Wisconsin Department of Transportation

Proposal #26: 4589-01-72, WISC 2025382
Brown Co, CTH PP
Man Cal Road to STH 96
CTH PP
Brown County

This is Addendum No. 01, which provides for the following:

ADDENDUM NO. 01

Addendum No. 01
ID 4589-01-72
Revised Sheet 3
March 5, 2025

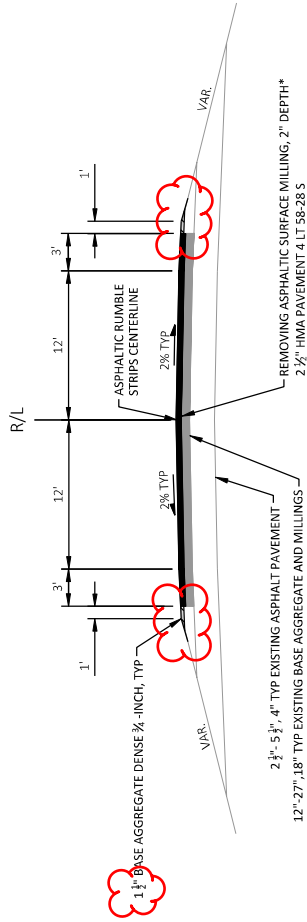
Revised Plan Sheets	
Plan Sheet	Plan Sheet Title (brief description of changes to sheet)
3	Typical Sections, revised proposed shoulder depth in overlay areas
14,15,17,18	Misc Qty, revised shouldering and EBS-related quantities

The depth of the new gravel shoulder adjacent to overlay areas was adjusted to more accurately reflect the amount of material that will be needed to bring the shoulder to grade with the new pavement.
